Re: Application 2023/93206 - Erection of single and two storey extensions and raised patio to existing dwelling and detached garden building.

**Figure 4: Proposed plans showing proximity of trees and privacy at risk.**

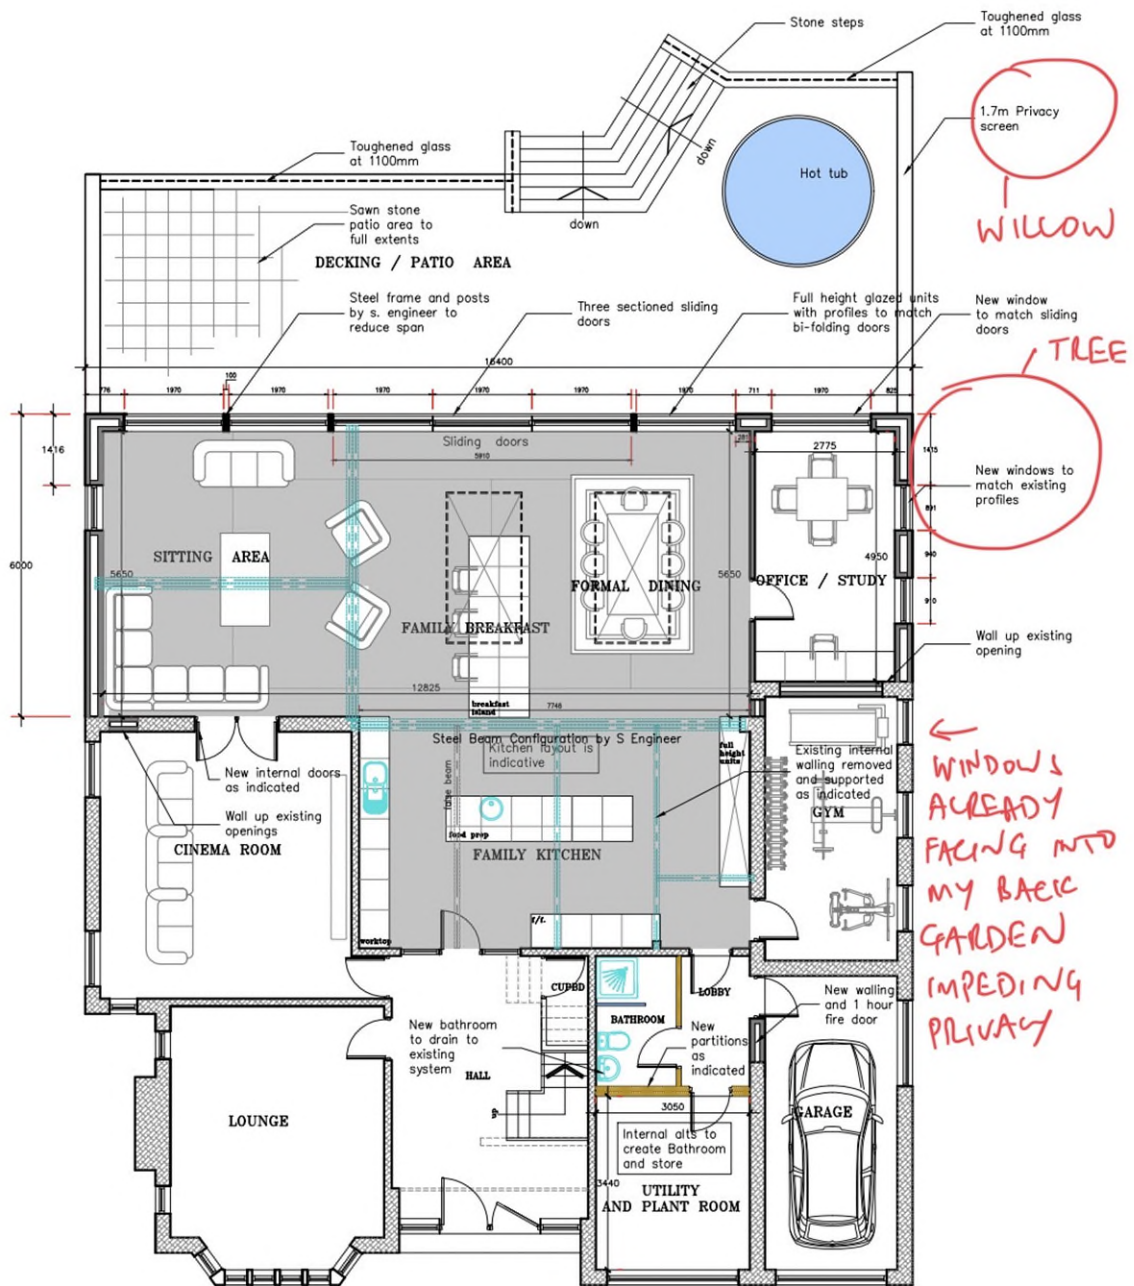
Again, the proposed extension to the back lies very close to our fence where another tree stands (in addition to the willow). I am concerned about whether this could also be damaged in the process of digging the foundations. The previous extension at the back already has windows facing into our garden impeding privacy. A further extension to the back will add further to the view of our garden from 4 Dorchester Road. See figures 1, 2, 3 & 4.
